Kamman Hydrological Assessment with Arger Cover Letter

Re: Mountain Peak Winery, Use Permit # P13-00320-UP

Subject: Review of Initial Study and Negative Declaration
Mountain Peak Winery: Use Permit #P13-00320-UP
3265 Soda Canyon Road, Napa, CA 94558 (APN: 032-500-033)

Figure 1: Location of Mountain Peak Vineyard wells, off-site spring-fed pond and upstream extent of wetted channel in tributary to the east of the project site.

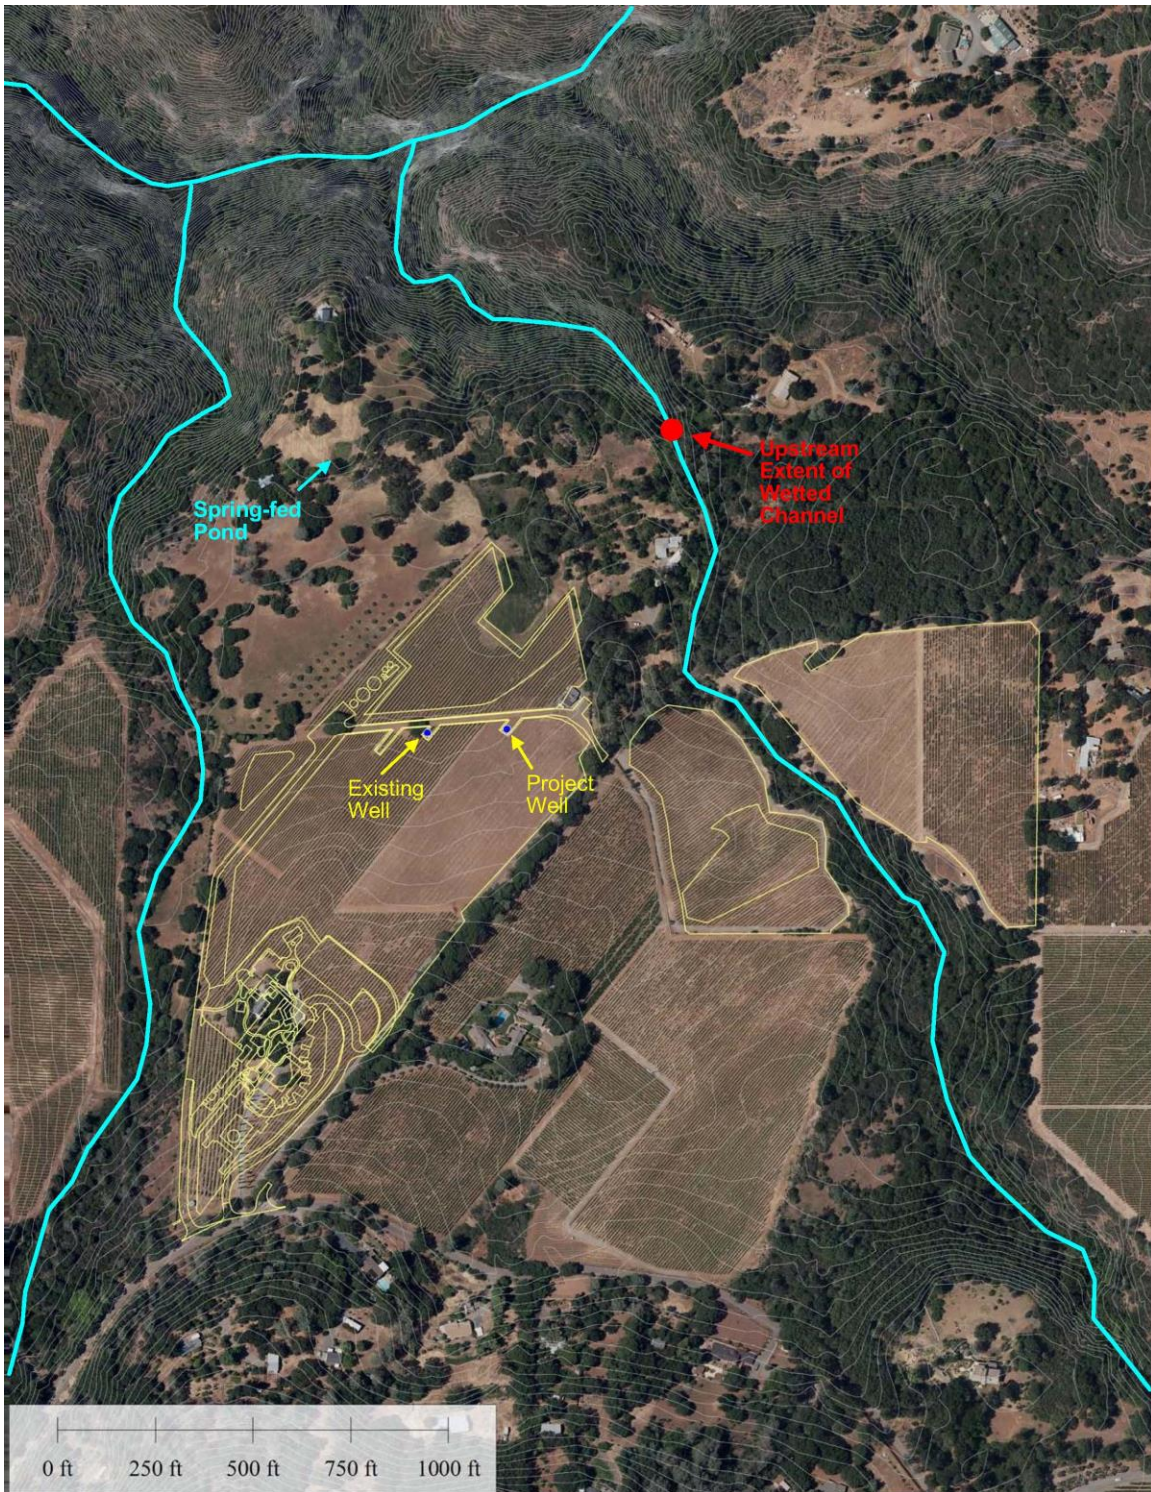
There is an existing off-site spring-fed pond located 700-feet north of the existing vineyard well and 800-feet northwest of the proposed project well site (see Figure 1). According to the property owner, the annual late summer (September) water level in the pond has been getting lower and lower over the past decade. In July of 2016, this spring-fed pond had dried up completely for the first time in at least 22 years (record of

observation of current landowner). The impact of increased vineyard groundwater pumping on the spring supply to this pond has not been addressed in project documents. Review of project groundwater level monitoring data indicates that groundwater flow gradients within the project vicinity are generally from south to north (i.e., towards Rector Creek and canyon). The County WAA clearly indicates that a Tier 2 (Well and Spring Interference Criterion) analysis is required for springs located within 1500 feet of the proposed project wells. The project WAA does not provide the results of a Tier 2 analysis. Therefore, the project has not demonstrated that there will be no adverse impact to the adjacent spring-fed pond and associated water supply and ecological benefits associated with the pond.

FIGURE 4
WATER LEVELS DURING CONSTANT RATE PUMPING TEST
3265 SODA CANYON ROAD

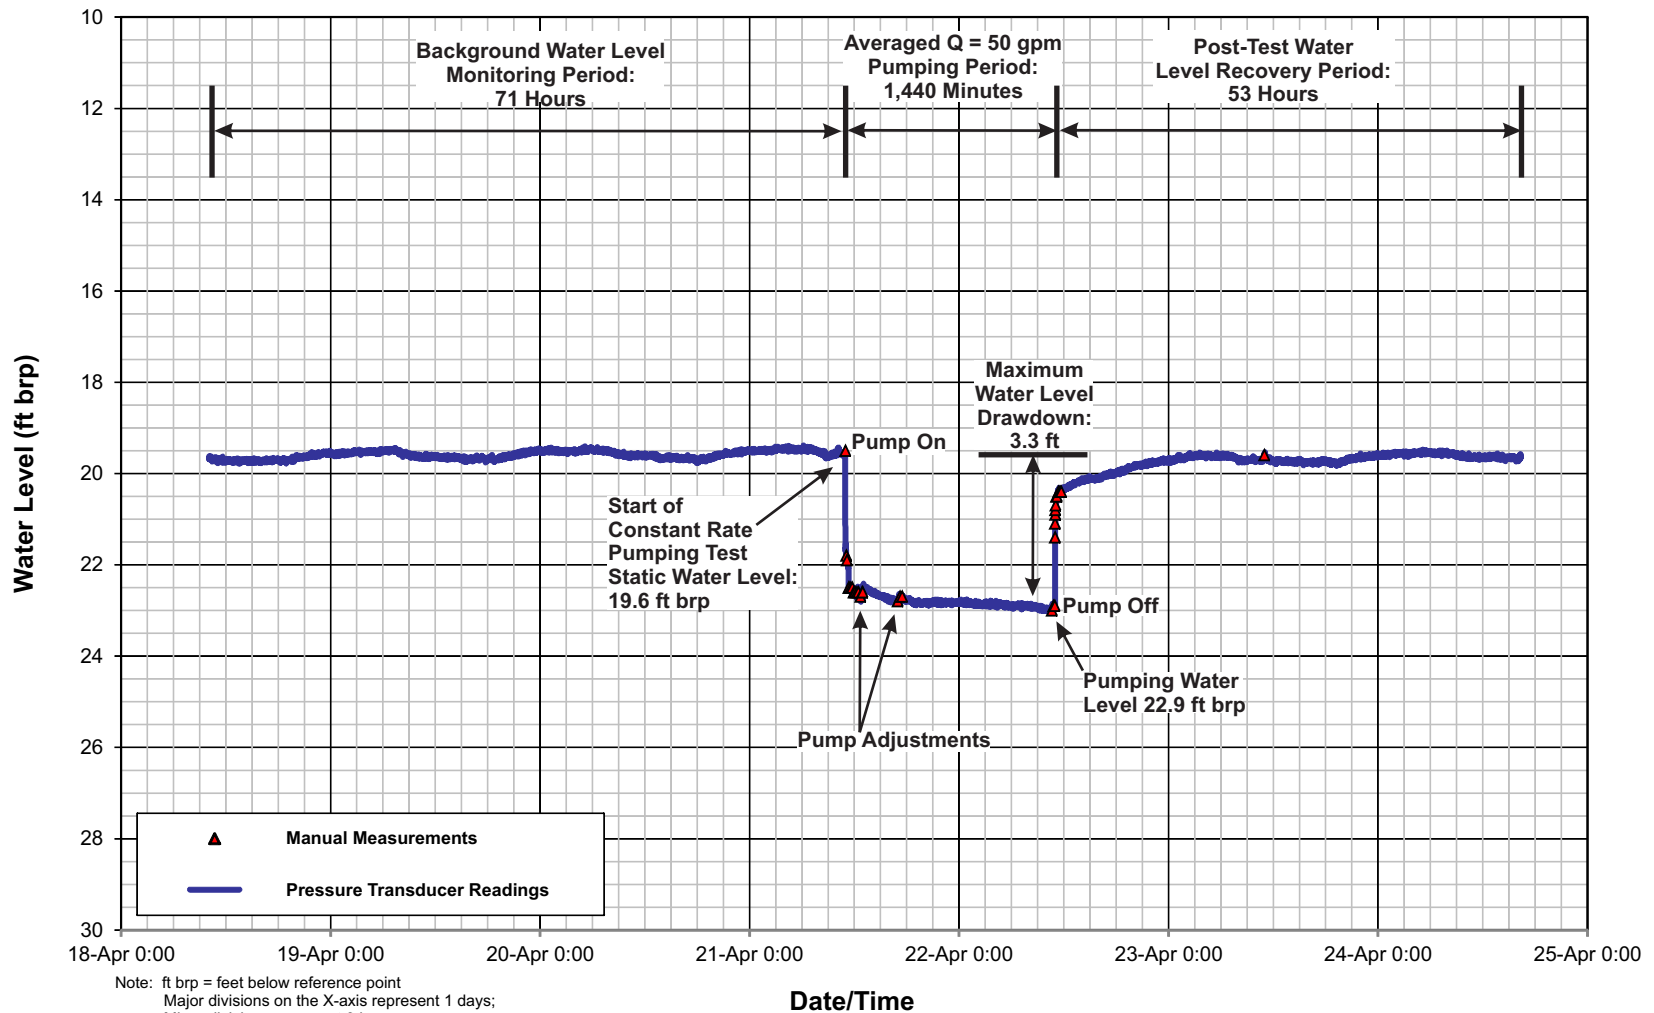
RCS describes the April 2014 constant rate pumping test, which resulted in 3.3 feet of water level drawdown while pumping the well at 50 gpm (see Figure 4 and 7 of the RCS 2015 report, provided in Attachment B). The effects of this pumping were not monitored in any surrounding on- or off-site wells, ponds or springs. However, during background water level monitoring of the existing well for multi-day periods before and after the pump test, small (less than 0.5 feet) changes in water levels are attributed to pumping effects by off-site wells or “natural diurnal fluctuations in the aquifer system.”

The well yield test completed in April 2014 fails to look for or evaluate potential project impacts on groundwater levels and seasonal storage surrounding the site. Completing the well pump test during the wet season precludes the analysis and evaluation of greater drawdown that is more pronounced during the dry season. The lack of monitoring the effects of project pumping on off-site wells, springs and seeps precludes the ability to evaluate potential significant impacts on groundwater resources.

FIGURE 7
MOUNTAIN PEAK WELL NO. 1
WATER LEVEL DATA

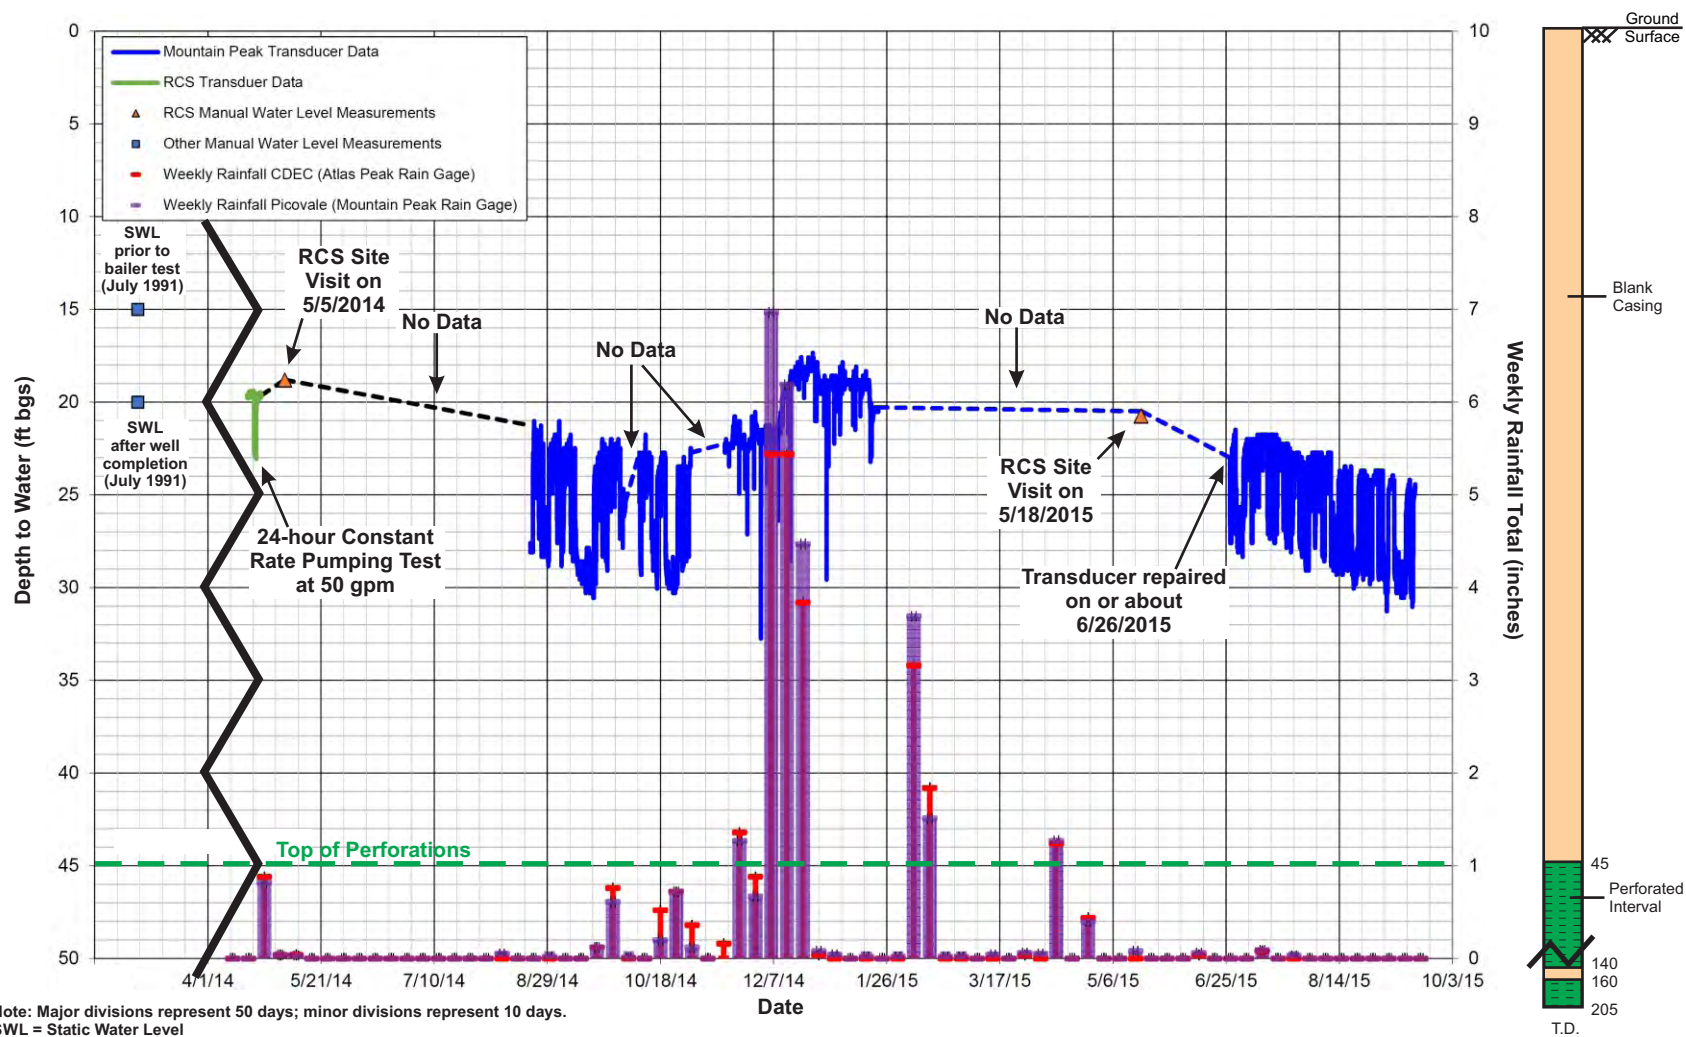
RCS also presents continuous water level monitoring data in the existing site well for the summer/fall period of 2014 and 2015 as well as winter of 2014/15. During the summer/fall monitoring periods, the drawdown in the well ranged from 6 to 7 feet, twice the magnitude of drawdown measured during the 50 gpm pump test. Typically, increases in water level drawdown in a pumping well are in response to higher pumping rates. With everything else being equal, this would suggest that the existing well was pumped at much higher rates than 50 gpm. Water level hydrographs also indicated that pumping was completed on a continual basis for multiple days over several intervals. This raises a number of questions and concerns. First, why would the vineyard pump at rates higher than 50 gpm, which is presented as a maximum project pumping rate? Acknowledging that the effects of well pumping at off-site wells may be seen at the existing site well, what is the effect of pumping the existing and proposed project wells on surrounding off-site wells? What is the radius and magnitude of influence of pumping the existing well on the surrounding aquifer?

In their 2015 report, RCS state (page 16), *“Important to note from Figure 7 is that the water levels in the onsite well have remained essentially unchanged over time. Static water level data available throughout the period of record fluctuate from a high of 15 ft (just after the well was constructed and no significant pumping had occurred) to a low of roughly 24 ft in September 2015, which occurred near the end of this current irrigation season; the onsite well has been pumping for irrigation purposes.”* The statement of no change over time is hardly substantiated when presenting only two measurements from a single month in 1991 in comparison to discontinuous measurements over a year and a half period in 2014-15. Typically, temporal trends in groundwater level data require regular measurements over a longer period during similar seasonal periods (e.g., summer or winter) and multiple water year types. At best, comparison of July water level measurements for the three years available in Figure 7 (see Attachment B) indicate a water level decline of 6 feet between 1991 and 2014 and additional 1-foot decline between 2014 and 2015. Arguably, a 7 foot decline in summer water levels as measured during dry water year types reflects a long-term decline in groundwater levels and aquifer storage. Such a change is consistent with a decline in aquifer storage due to long-term annual groundwater withdrawals that exceed annual recharge as measured in 2015.
